La Vista City Centre Theater Preliminary Plat

RECOMMENDATION REPORT

CASE NUMBER: PSPP 19-0001

RE: Preliminary Plat – Initial Review
La Vista City Centre Theater

SHEET
C1.1

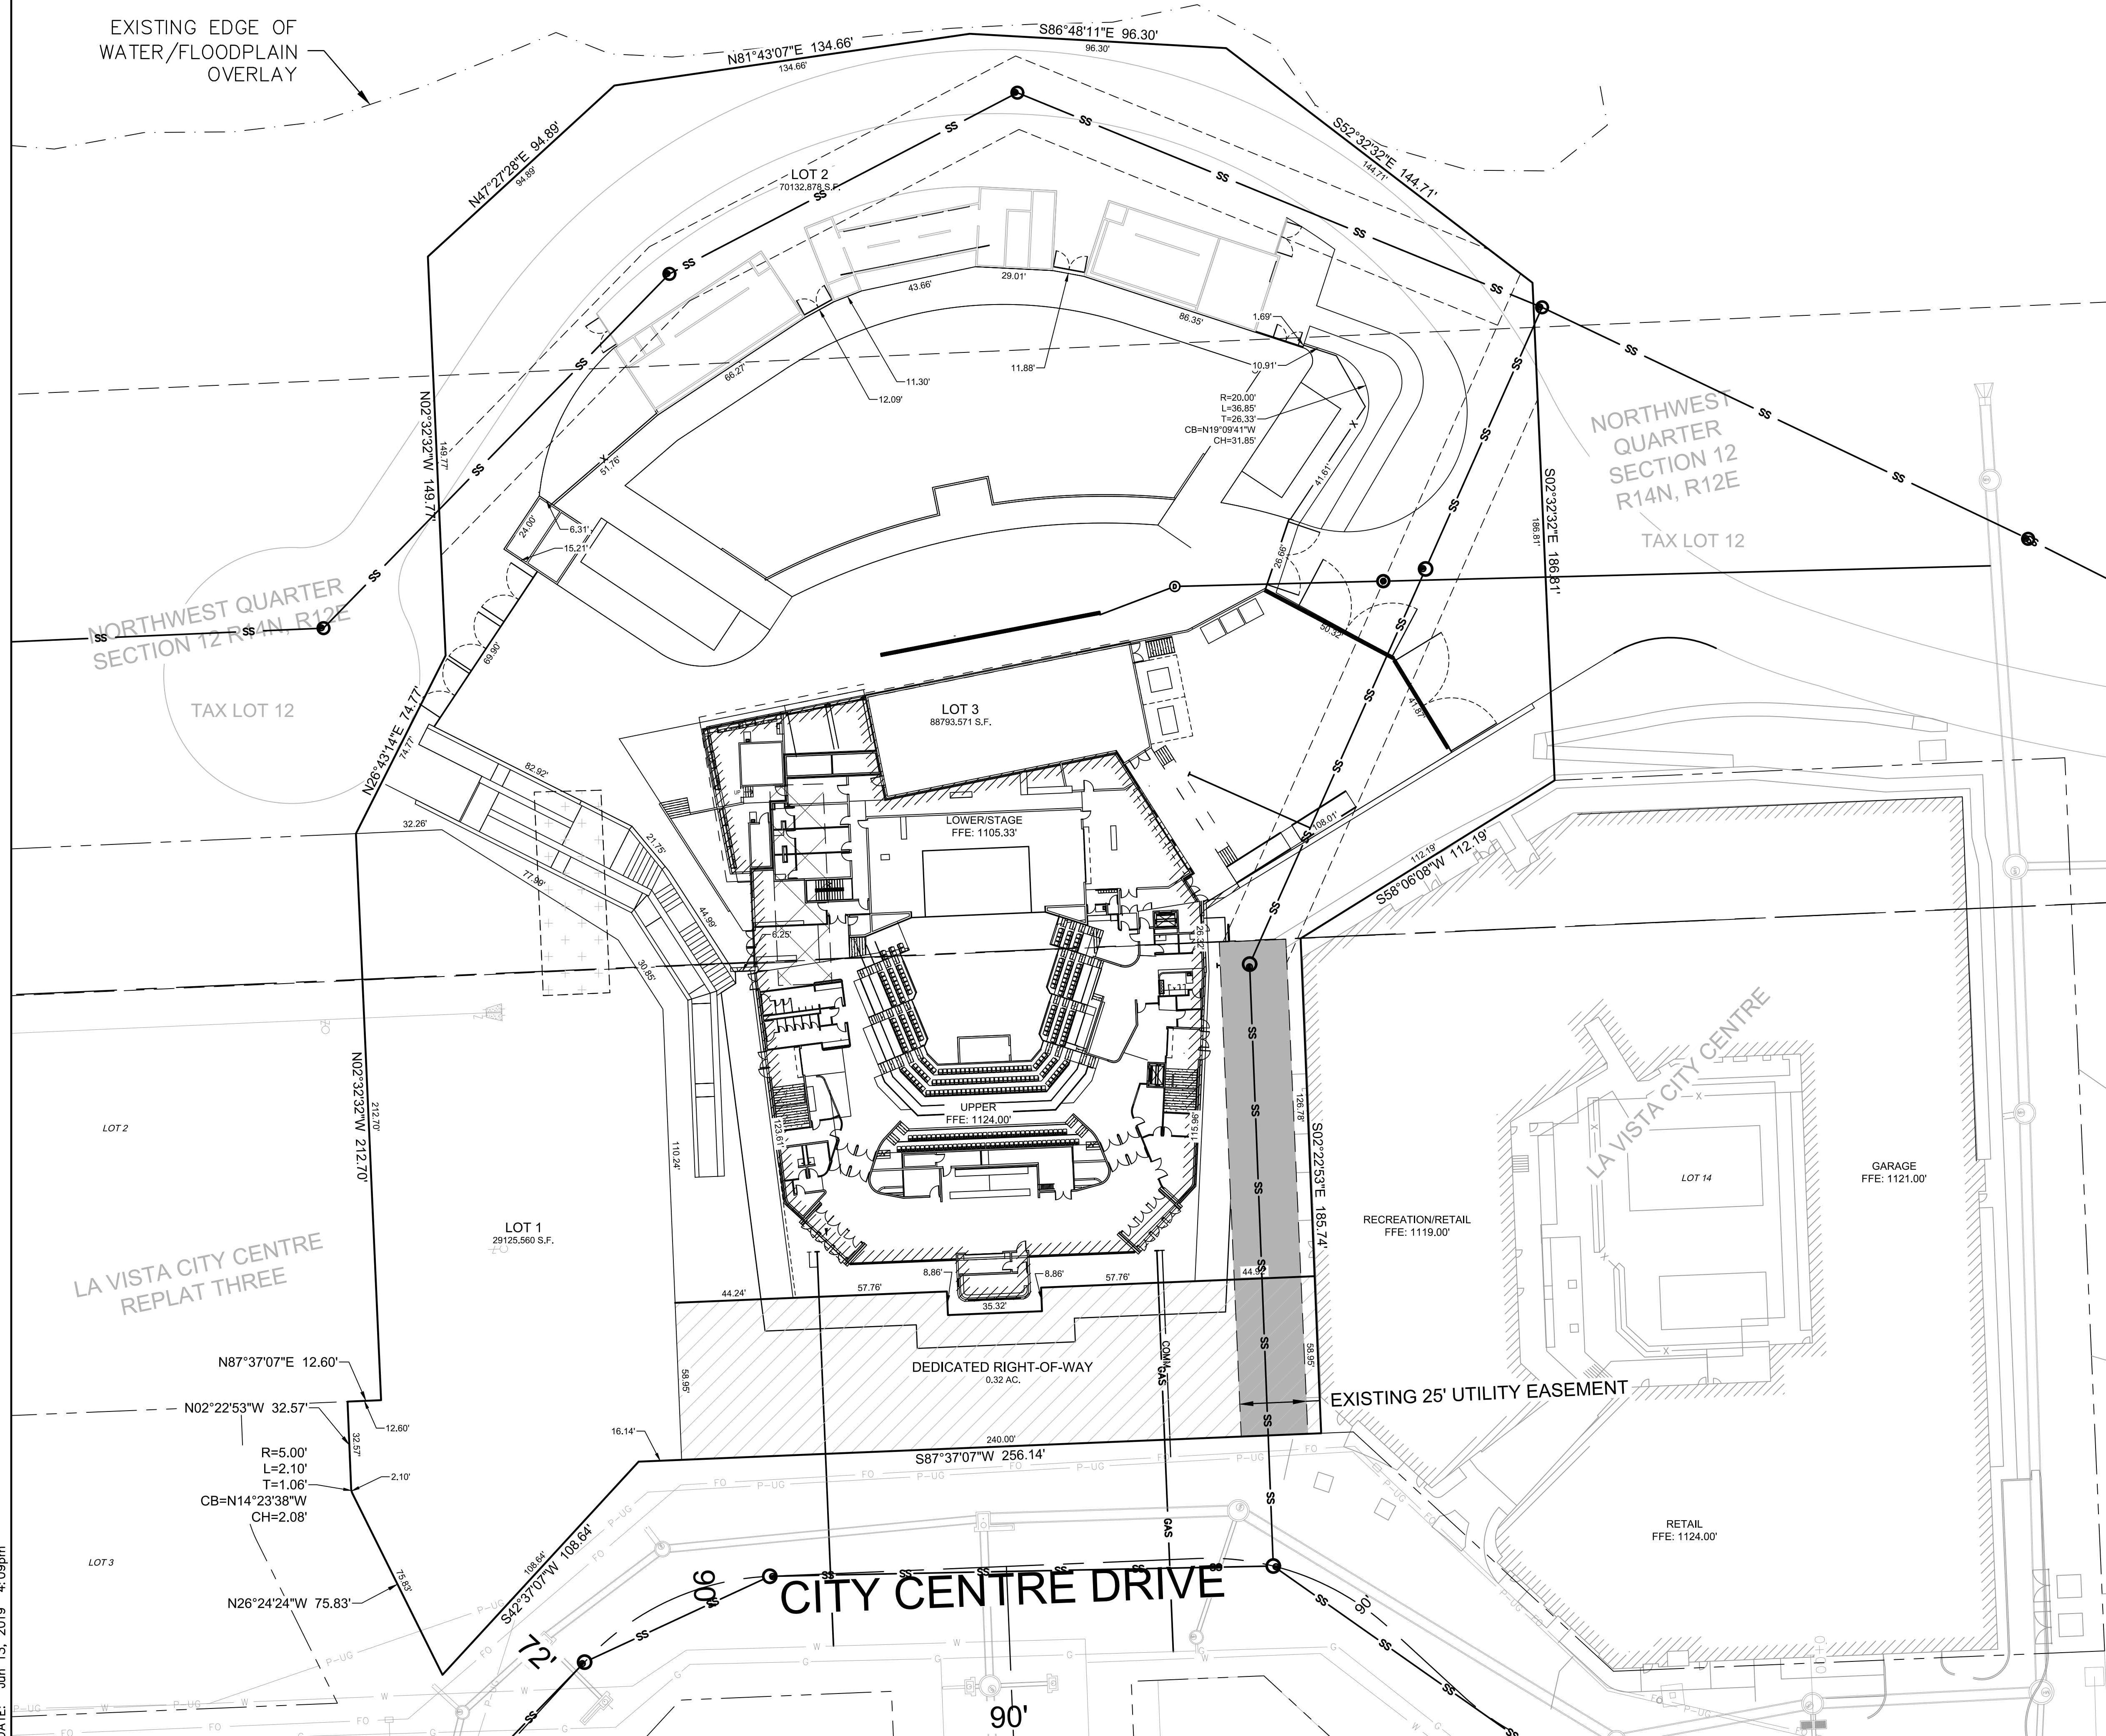
1. Article 3.03.02: Due to the nature of this preliminary plat please include proposed floor elevations on Lot 14 and on Lot 1. This should include the main floor elevation on Lot 14 and the bottom floor, stage and upper floor elevations on Lot 1.

2. Article 3.03.06: Please provide a legal description of the area being platted, including acreage of the proposed development.
3. Article 3.03.07: The location of the existing edge of normal water surface in the Civic Center Park lake needs to be shown as this affects the boundary of proposed Lot 2. The location of the relocated sanitary outfall sewer north of Lots 1 and 2 should be shown. Both of these can be based on the TD2 topographic survey of the "interface" area dated January 31, 2019. If Olsson does not already have a copy of this survey, the City will make arrangements for Olsson to receive it.

4. Article 3.03.09: The proposed lot areas should be identified in square footage and not acres since appraisals and negotiations will need the areas in square feet.

5. Article 3.03.10: An easement for the public sanitary sewer through Lots 1 and 2 to the outfall sewer needs to be shown. Any storm sewer easements (public or private) proposed over Lots 1 through 3 need to be shown. There should be notations in regards to any proposed blanket easements for ingress and egress amongst the lots and for public benefit.

6. Article 3.03.12: It appears that an existing sanitary sewer easement and an existing storm sewer easement will need to be released. Please add notations indicating the intent in regards to these easements.

7. Article 3.03.13: Please provide any established floodplain overlay lines. Per Zoning Ordinance Section 5.18, the development's proximity to the delineated Zone A Floodplain will most likely require a Floodplain Development Permit be obtained as to ensure flood hazards are analyzed as to satisfy the conditions of the aforementioned zoning ordinance.

1. Article 3.03.02: Due to the nature of this preliminary plat please include proposed floor elevations on Lot 14 and on Lot 1. This should include the main floor elevation on Lot 14 and the bottom floor, stage and upper floor elevations on Lot 1. **Response: Elevations have been provided.**

2. Article 3.03.06: Please provide a legal description of the area being platted, including acreage of the proposed development. **Response: Legal description has been provided.**

3. Article 3.03.07: The location of the existing edge of normal water surface in the Civic Center Park lake needs to be shown as this affects the boundary of proposed Lot 2. The location of the relocated sanitary outfall sewer north of Lots 1 and 2 should be shown. Both of these can be based on the TD2 topographic survey of the "interface" area dated January 31, 2019. If Olsson does not already have a copy of this survey, the City will make arrangements for Olsson to receive it. **Response: This was coordinated with TD2 and the boundary has been revised to accommodate the edge of waterway. Relocated sanitary sewer has also been provided.**

4. Article 3.03.09: The proposed lot areas should be identified in square footage and not acres since appraisals and negotiations will need the areas in square feet. **Response: This has been updated**

5. Article 3.03.10: An easement for the public sanitary sewer through Lots 1 and 2 to the outfall sewer needs to be shown. Any storm sewer easements (public or private) proposed over Lots 1 through 3 need to be shown. There should be notations in regards to any proposed blanket easements for ingress and egress amongst the lots and for public benefit. **Response: This easement has been added for the existing line through the lot.**

6. Article 3.03.12: It appears that an existing sanitary sewer easement and an existing storm sewer easement will need to be released. Please add notations indicating the intent in regards to these easements. **Response: This will be shown as released on the preliminary plat.**

7. Article 3.03.13: Please provide any established floodplain overlay lines. Per Zoning Ordinance Section 5.18, the development's proximity to the delineated Zone A Floodplain will most likely require a Floodplain Development Permit be obtained as to ensure flood hazards are analyzed as to satisfy the conditions of the aforementioned zoning ordinance. **Response: Floodplain line has been shown. If permitting is needed, this will be provided with the construction plans.**

SHEET
C3.1

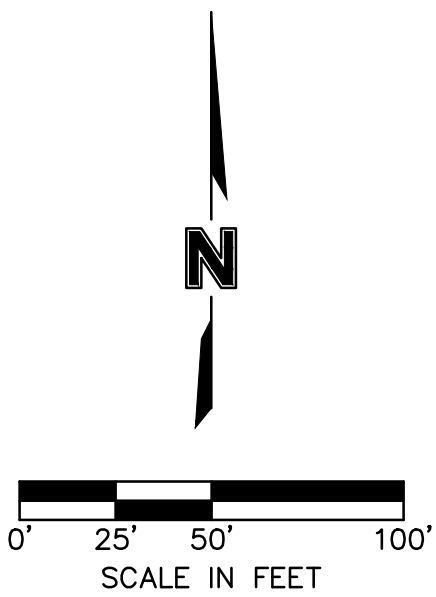
9. Article 3.03.16: On Sheet C3.1 some notations or illustrations are needed to address this requirement. The overall disturbed area will exceed five acres and add notations that sediment traps/basins, silt fences, and inlet filters will be utilized for sediment control at a minimum. Dependent on which entity undertakes the site preparation grading for these lots will identify which erosion control permit needs to be modified in Permix to include this area.

11. Article 3.03.20:
 - a. Per Item 2 above, show the sanitary outfall sewer.
 - b. The storm drainage plan (Sheet C3.1) needs to include conceptual information for proposed water quality treatment. The 2-year peak runoff increase can be addressed in the storm water detention facility in Civic Center Park.

- c. Information concerning a PCSMP plan needs to be provided on Sheet C3.1. This would include reference to the current plan for PCSMP No. 20170324-3736P and particularly Note 2 on Exhibit "B". Notations as to how runoff from the proposed truck dock and bus parking aprons will be treated are needed at a minimum. These locations have the most potential for pollutants that could affect the lake.

9. Article 3.03.16: On Sheet C3.1 some notations or illustrations are needed to address this requirement. The overall disturbed area will exceed five acres and add notations that sediment traps/basins, silt fences, and inlet filters will be utilized for sediment control at a minimum. Dependent on which entity undertakes the site preparation grading for these lots will identify which erosion control permit needs to be modified in Permix to include this area. **Response: Note has been added.**

11. Article 3.03.20:
 - a. Per Item 2 above, show the sanitary outfall sewer. **Response: Provided.**
 - b. The storm drainage plan (Sheet C3.1) needs to include conceptual information for proposed water quality treatment. The 2-year peak runoff increase can be addressed in the storm water detention facility in Civic Center Park. **Response: Storm quality structure has been provided.**

- c. Information concerning a PCSMP plan needs to be provided on Sheet C3.1. This would include reference to the current plan for PCSMP No. 20170324- 3736P and particularly Note 2 on Exhibit "B". Notations as to how runoff from the proposed truck dock and bus parking aprons will be treated are needed at a minimum. These locations have the most potential for pollutants that could affect the lake. **Response: PCSMP information has been added to sheet C3.1 and PCSMP # has been added. A trench drain has been added along the front of the truck dock and will tie in before the vortex system.**
